2024 State Touring Routes PIM #2, Hybrid Format

Project/File: 192800236
Date/Time: Monday October 16, 2023 / 5:30 pm
Location: Phillis Wheatley Library
Attendees: See Attached Sign-In Sheet
Distribution: Project Website

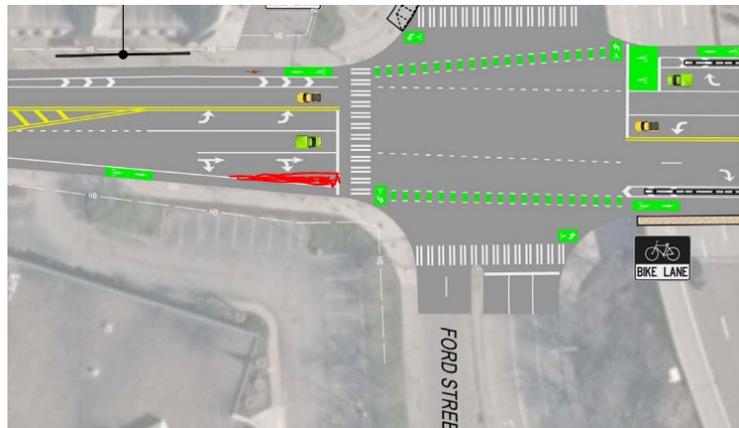
Public Question/Comment (Steve Roll): Overall, I think the design is really great! I focused on the sections (W. Main in particular) on the ATP Bike Spine Network.

- The continuous, mostly-buffered bike lane on the Spine Network is good although I would've preferred a separated/protected bike lane like the new East Main (Culver to Goodman).
- I love the Low Profile Concrete Barriers to protect the bike lane to prevent cars from parking in the bike lane and drivers from intruding.
- The traffic calming and pedestrian improvements are great! I especially like the raised median with planted trees.
- I like the road diet (4:3) conversion. Even as a driver, one lane each way with a center turning lane feels safer and less stressful.

Response: Thank you for the comment.
